SERVICE BULLETIN NO: 53-001

FUSELAGE - REAR FUSELAGE STABILIZER-TRIM ATTACHMENT COMPONENTS - INSPECTION

PILATUS
PC-6
SERVICE BULLETIN

Stabilizer-trim Attachment Components - Inspection and Replacement
Figure 1

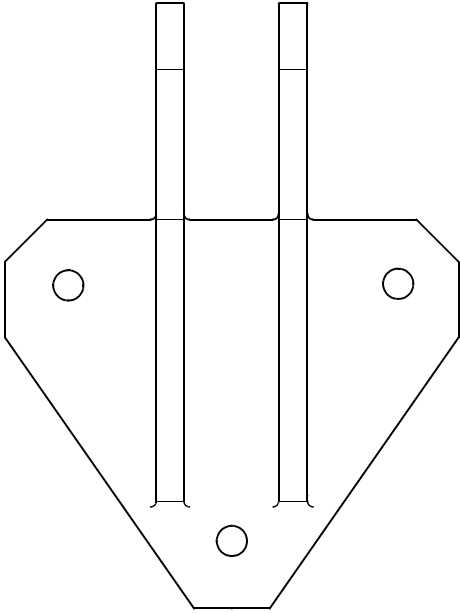
- Fitting (116.40.06.112) or (116.40.06.033) in aircraft with electrical horizontal-stabilizer control-systems (CONFIG 1)
- Connecting piece (6232.0026 - all variants) in aircraft with mechanical horizontal-stabilizer control-systems (CONFIG 2)
- Bearing fork (116.40.06.034) in all horizontal stabilizers (CONFIG 1)
- Bearing support assembly (6304.0023) (Ref. Fig 1, Items 2 and 3)

- (a) Do inspections for crack damage in the applicable stabilizer-trim attachment components and replace defective parts as necessary. No cracks are permitted. All crack damaged components must be replaced.
- (b) Replace Fairchild type connecting pieces (6232.0026) (CONFIG 2) with PILATUS type connecting pieces (6232.0026) without inspection, to prevent possible crack damage problems.
- (c) Replace fittings 116.40.06.033, without an index after the part number, (Ref. Fig. 2) with fittings 116.40.06.033, with an index after the part number or 116.40.06.112, without inspection, to prevent possible crack damage problems.

- (1) Remove the fitting (6). This step is only applicable for CONFIG 1 aircraft.
 - (a) Remove the nuts (7), washers (5), bolts (4).
 - (b) Remove the fitting (6) from FR12a.
 - (c) Discard the fitting if it is P/N 116.40.06.033, without an index after the part number.

- (2) Remove the connecting piece (9). This step is only applicable for CONFIG 2 aircraft.
 - (a) Use a 3,2 mm (0.126 in.) diameter drill to remove the rivet which attaches the connecting piece (9) to FR12a (Ref. ROM, Chap 2). This step is only applicable for CONFIG 2 aircraft with Fairchild type connecting pieces.
 - (b) Remove the nuts (11), washers (10), bolts (8) and disassemble the connecting piece (9) from FR12a. Discard Fairchild type connecting pieces, these must be replaced.
 - (c) Deburr the rivet hole in FR12a. This step is only applicable for CONFIG 2 aircraft with Fairchild type connecting pieces.

- All surfaces of the fitting (6) or connecting piece (9)
 - The surfaces of the bearing fork (12) or bearing supports (2) and (3) to which you have access

- The location on the surface of FR12a where the fitting (6) or connecting piece (9) was installed
 - (b) Obey the manufacturers instructions and use dye flaw detection procedures (fluorescent or color contrast) to do inspections for cracks in the fitting (6) or connecting piece (9) and the bearing fork (12) or bearing supports (2) and (3) and the applicable area of RF12a. No crack damage is permitted. You must replace:

- Cracked components (Ref. Table - Component Replacement Data)
 - The two bearing supports (2) and (3) if only one is found cracked
 - FR12a if cracks are found

- (1) Install the fitting. This step is only applicable on CONFIG 1 aircraft.
 - (a) Obey the manufacturers instructions and apply layers of corrosion preventative (Material Item No. P07-001) as necessary to the applicable components and inspection areas (Ref. ROM, Chap 12).

- (d) Put the fitting (6) in position on FR12a and install the bolts (4), washers (5) and nuts (7).
 - (e) Obey the manufacturers instructions and use the solvent (Item No. P01-008 or approved alternative) to remove unwanted corrosion preventative.

- (iv) Put the connecting piece (9) in position on FR12a and install the bolts (8), washers (10) and nuts (11).
 - (v) Obey the manufacturers instructions and use the solvent (Item No. P01-008 or approved alternative) to remove unwanted corrosion preventative.

Difference Between Fittings 116.40.06.033
Figure 2

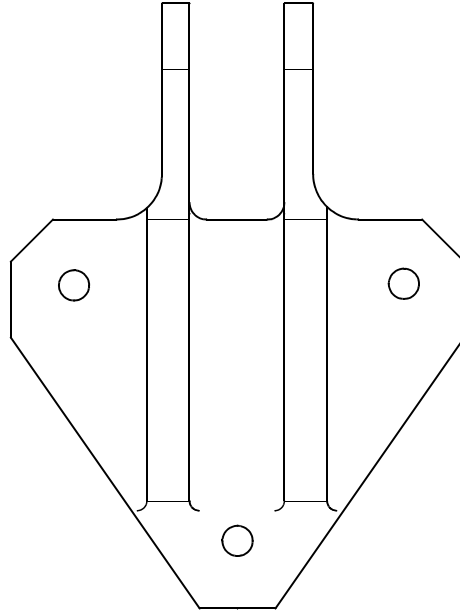
NOTE: These fittings can be identified by their lugs having a uniform thickness (Ref. Fig. 2). Fittings (116.40.06.033) with index A or B after the part number (which can be identified by their unequal lugs thickness) (Ref. Fig. 2) are not affected.

Revision No. 1 is issued to correct the tolerance of the actuator attachment hole diameters in the fitting (6) (CONFIG 1), to correct the applicability of the Service Bulletin, to add a new figure to show the differences between the fittings and to add the requirement to replace the fittings, P/N116.40.06.033, without an index after the part number.

NOTE: These fittings can be identified by their lugs having a uniform thickness (Ref. Fig. 2). Fittings (116.40.06.033) with index A or B after the part number (which can be identified by their unequal lugs thickness) (Ref. Fig. 2) require the inspection to be carried out.

- (1) Discard all fittings (6) P/N116.40.06.033, without an index after the part number.
